DAMPCOURSING Ltd

Our Ref: JD/GW Rep No: 34/756

RE: ANTRIM GROVE, LONDON NW3

Estimate

BASEMENT PLAN SCALE 1:50

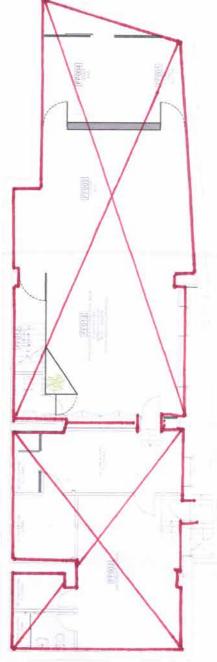
There is obvious penetration at the interface between the steel beams supporting the roof and the adjacent high earth levels. There are further concerns over damp readings from the floor, unconnected with the water dripping from above.

To the front the walls and floor appear to be sound although the skylight is badly affected by water penetration due to poor detailing around the skylight and the interface between the opening and the soffit requires repairs.

The section around the edges of the steel beams will require removal of the brick in-fill and opening up around the steel in order to form a water proof detail between the steel and the underlying substrate. This has not been closely examined at present.

We would advise the removal of the internal membranes from the walls to allow us to reinstate fresh membranes. However, it will be necessary to have a further look and assess the condition of the concrete behind. There may well be an additional requirement of waterproofing the concrete and stopping leaks prior to the installation of the membrane. This way the limescale can be controlled.

We will apply the Newton products around the front skylight in accordance with manufacturers instructions and this should control the moisture. However, we would advise that you will need to take up the skylight and allow us to take our materials up and over unto the slab and then you can re-bed the skylight in place.

To supply and install the John Newton 500 system. To apply anti-lime treatment. Lay 50mm closed cell insulation to floor. Supply and fit Newton basedrain to perimeter and drain to Chamber. Supply and fit Newton 508 clear to walls and Floor. Clear away debris.

To plug joint between end of steel beams and apply 2 coats of Newton 101F at junction.

To apply Newton 101F to exposed perimeter of skylight.
